1305 STEWART

PROJECT NUMBER
3034882-EG

PROJECT ADDRESS
1305 Stewart Street
Seattle, WA 98109

EDG 3 GUIDANCE

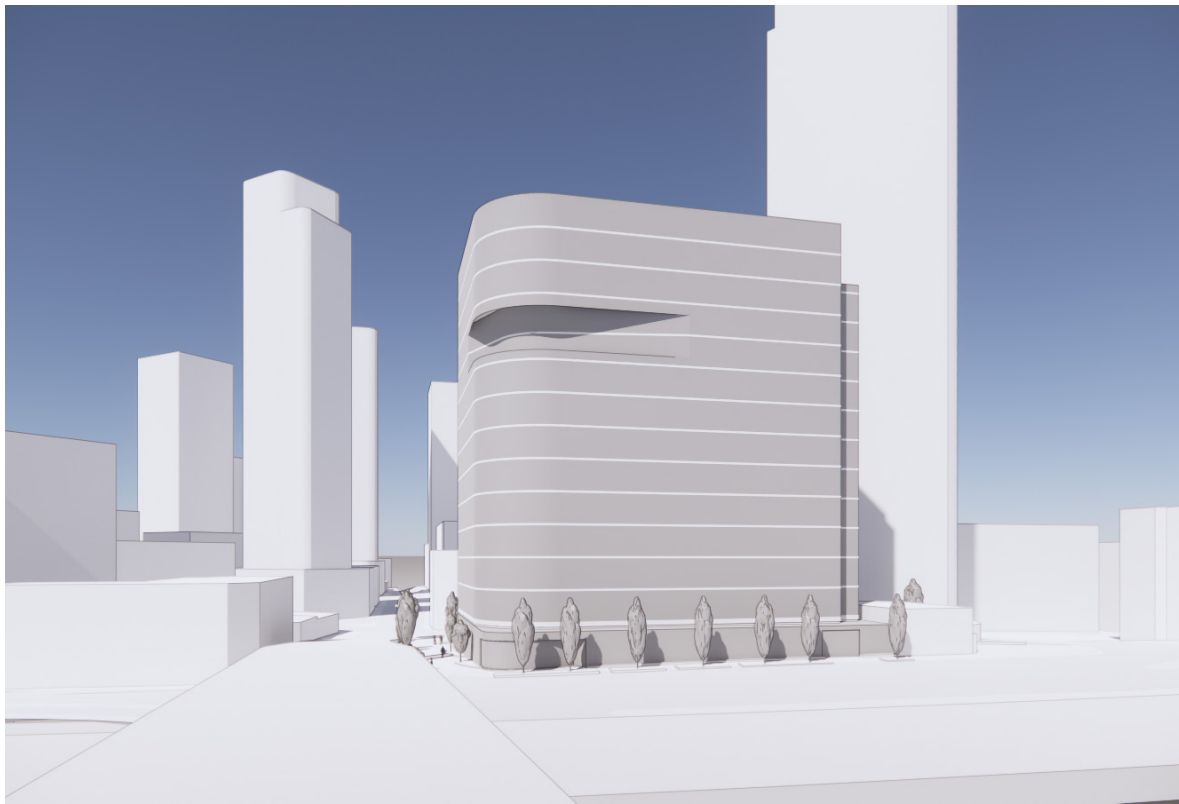
b. The Board strongly supported the architectural character of the precedent images provided on page 53 and appreciated the intent demonstrated in the accompanying sketches. The Board agreed that a similar level of depth, shadow and texture would be required in these large facades to create legible scale elements as called for in the Design Guidelines. (DC2-B, DC2-C, DC2-D, DC2-4, DC2-5, DC2-6)

b. The design incorporates depth, shadow, texture, and composition to create a legible scale design statement that responds to the physical and natural environment. The exterior materials have been selected to create a sense of warmth and distinction and to react with light and shadow to accentuate the building forms. The palette is meant to evoke a crafted northwest feel.

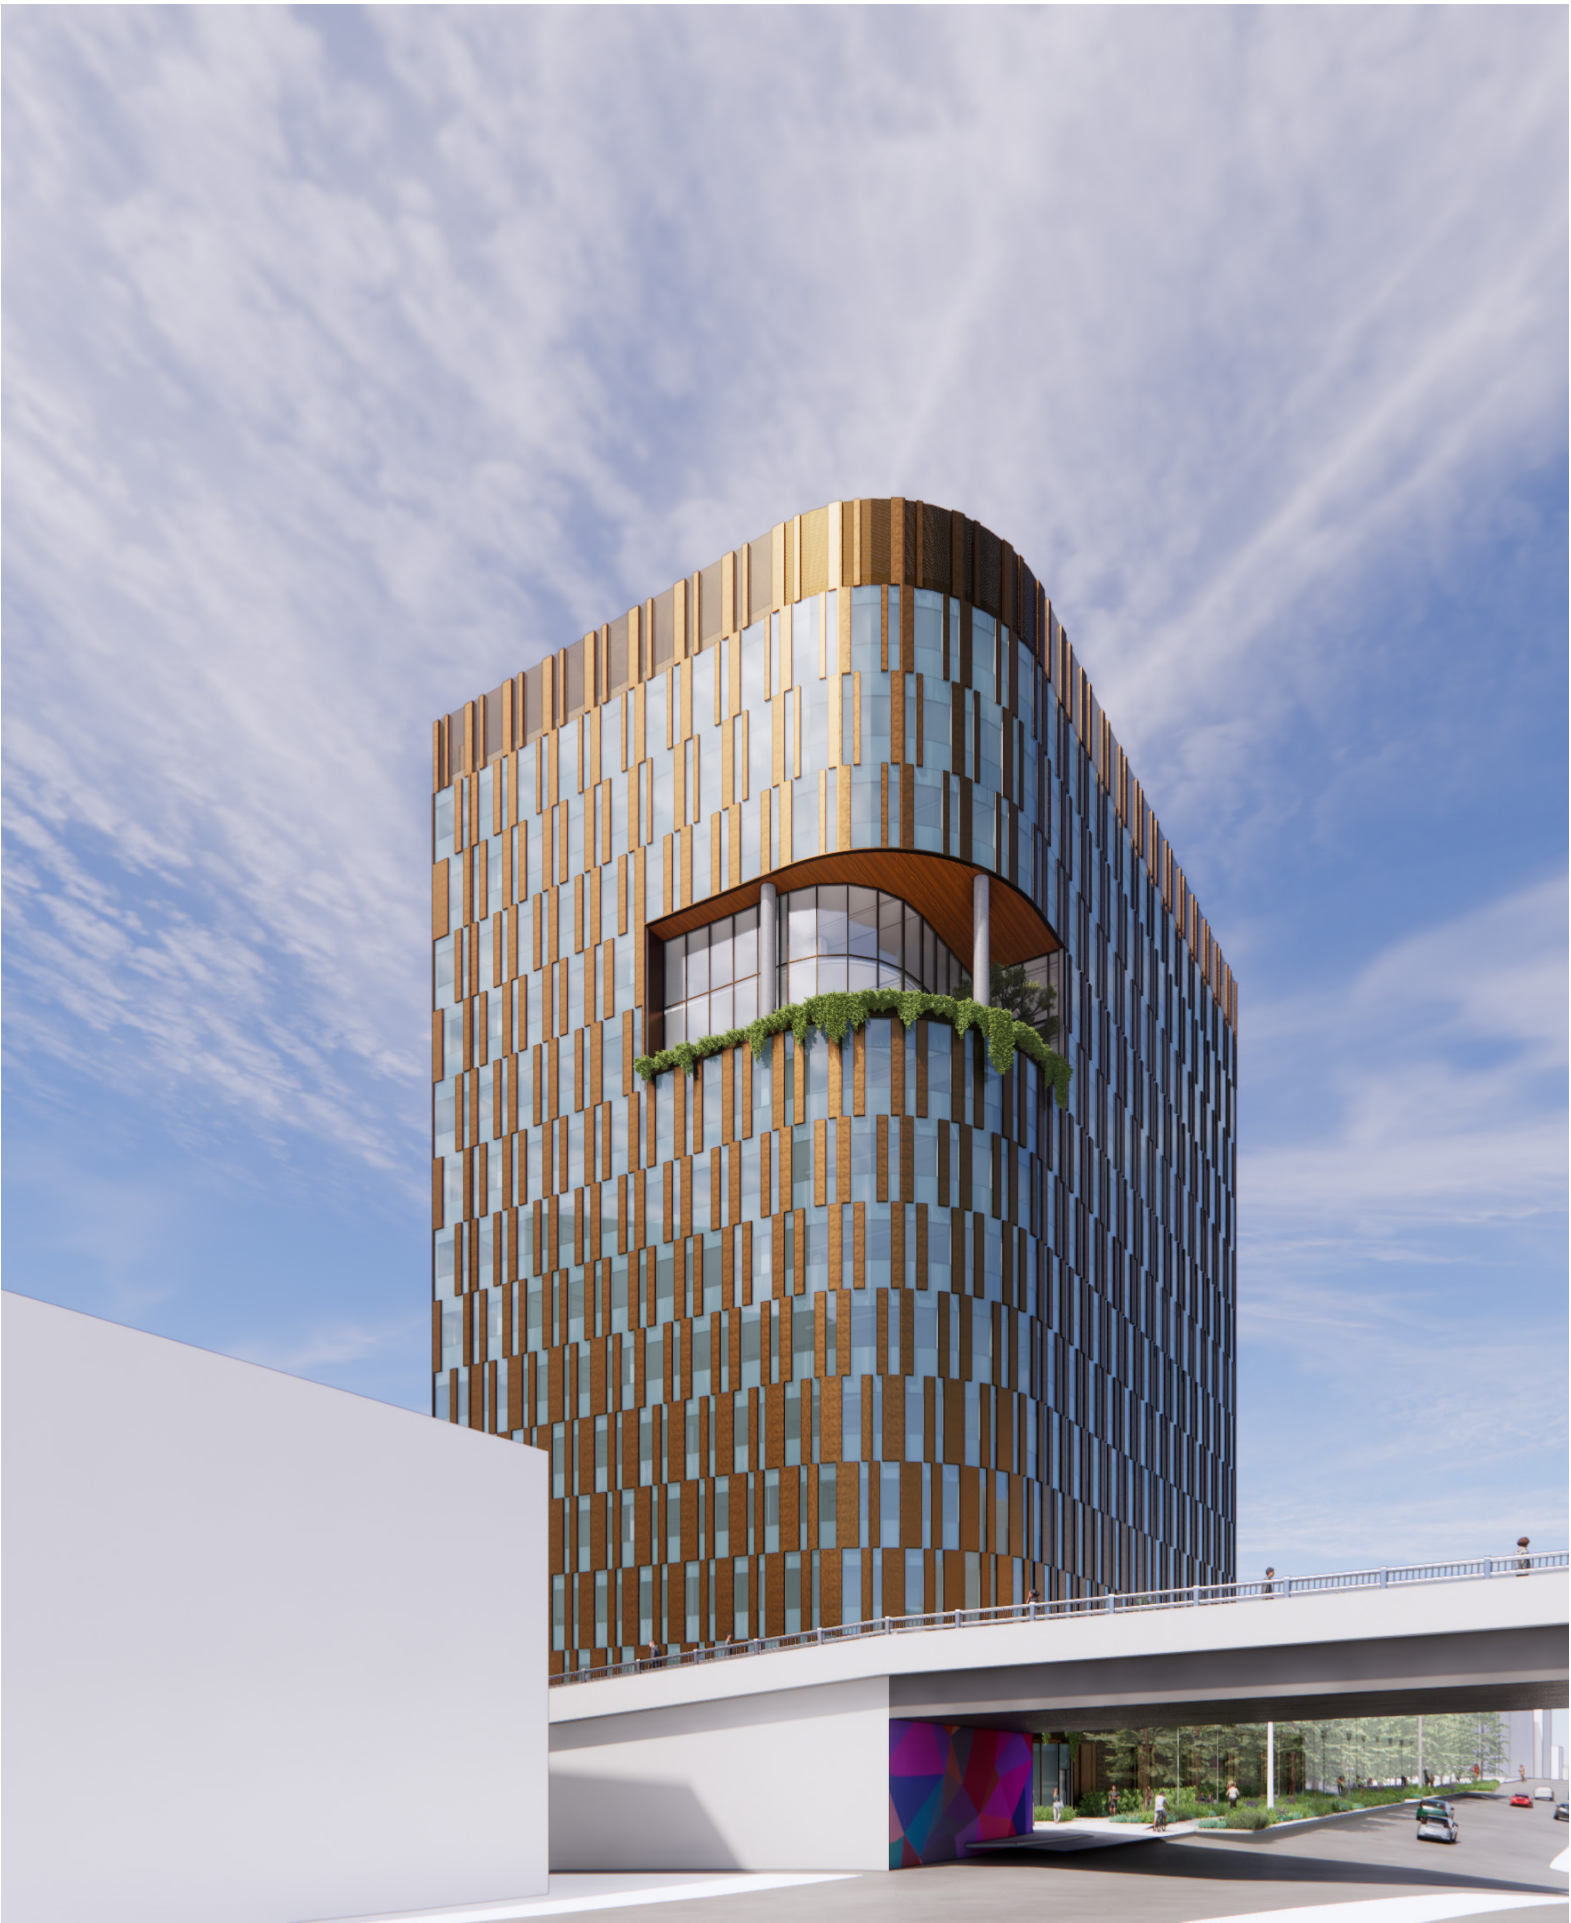
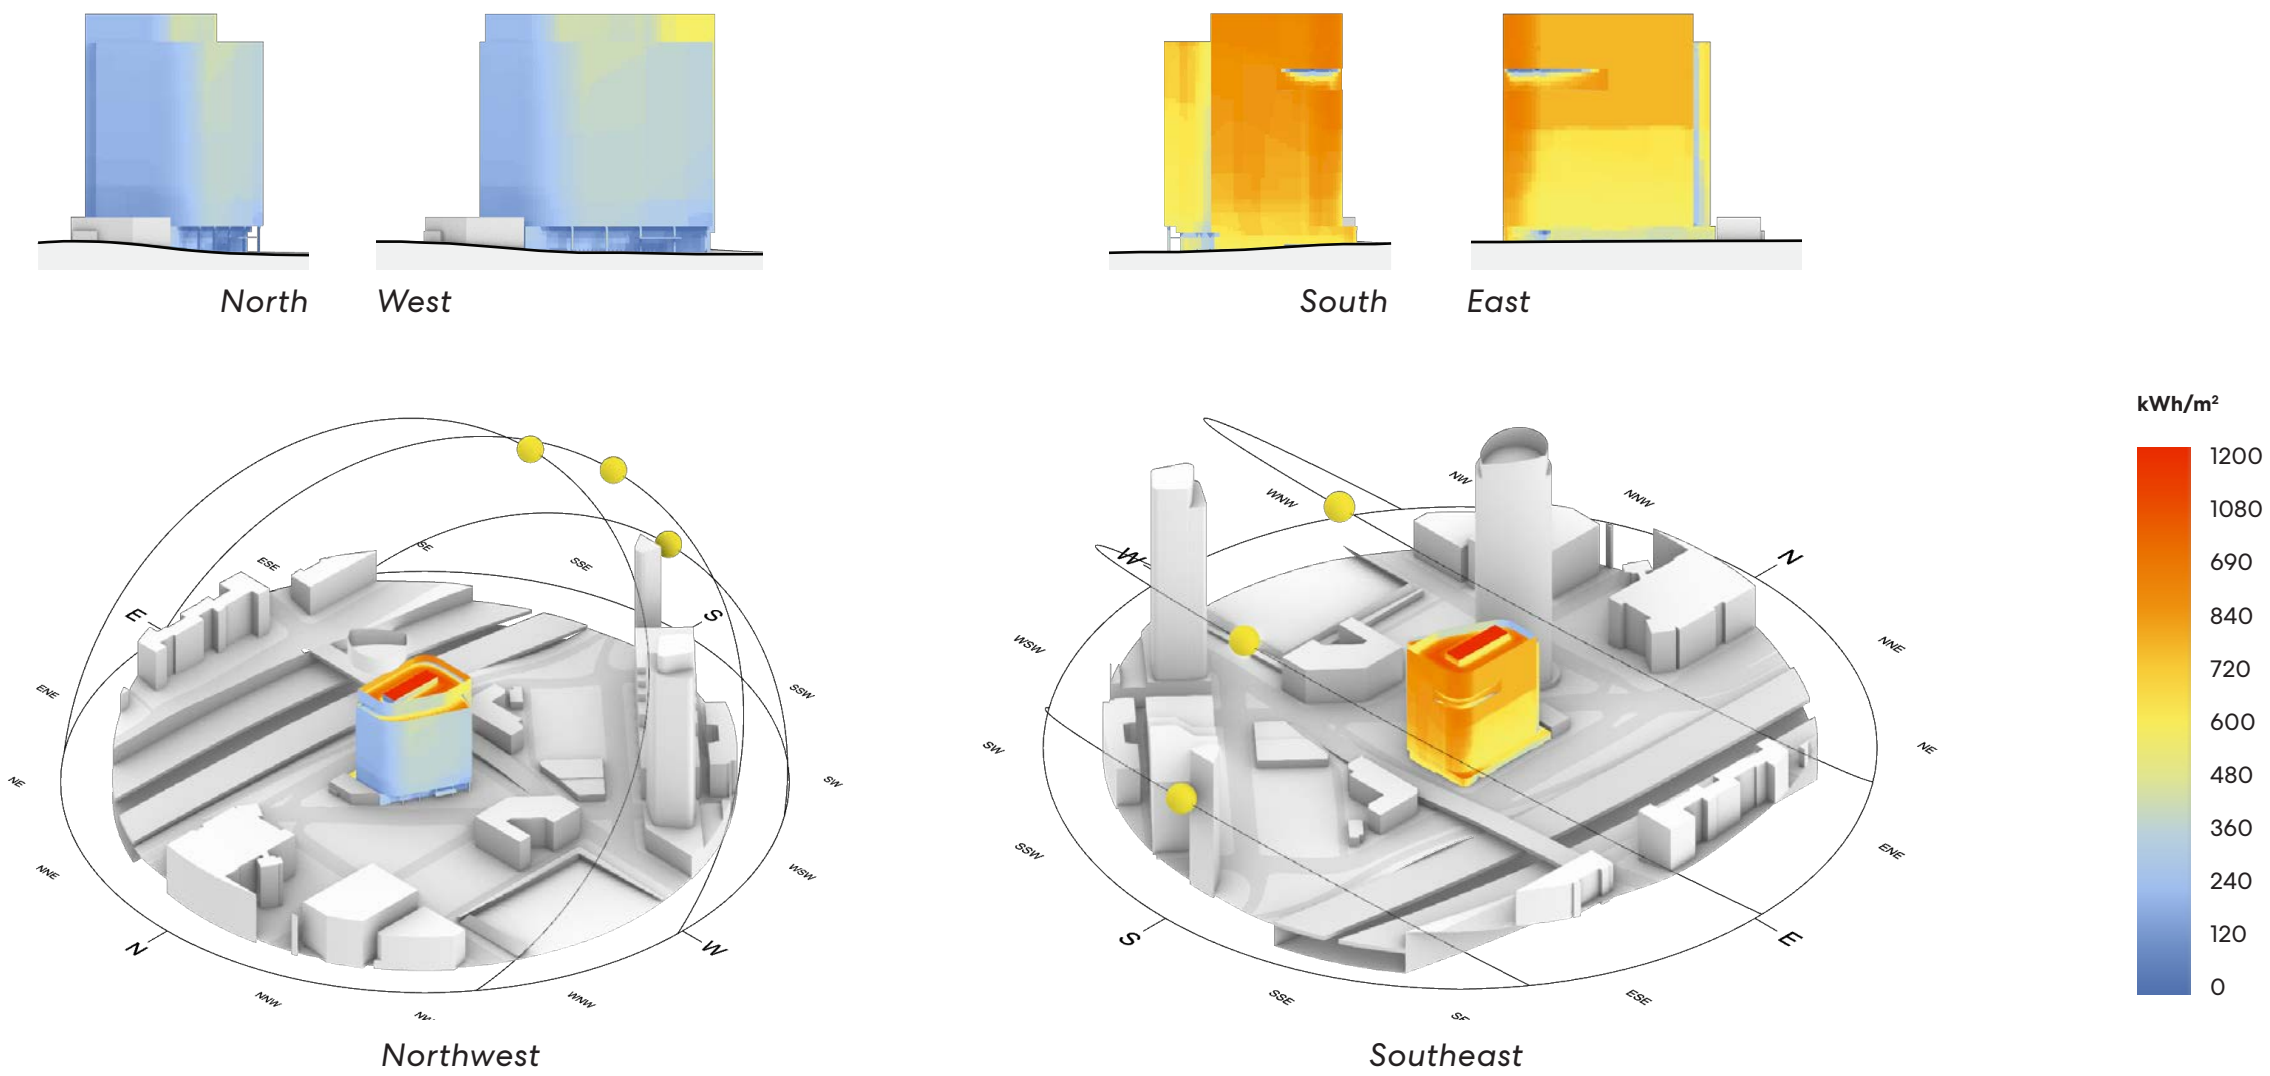
b. The Board strongly supported the architectural character of the precedent images provided on page 53 and appreciated the intent demonstrated in the accompanying sketches. The Board agreed that a similar level of depth, shadow and texture would be required in these large facades to create legible scale elements as called for in the Design Guidelines. (DC2-B, DC2-C, DC2-D, DC2-4, DC2-5, DC2-6)

b. The design incorporates depth, shadow, texture, and composition to create a legible scale design statement that responds to the physical and natural environment. The exterior materials have been selected to create a sense of warmth and distinction and to react with light and shadow to accentuate the building forms. The palette is meant to evoke a crafted northwest feel.
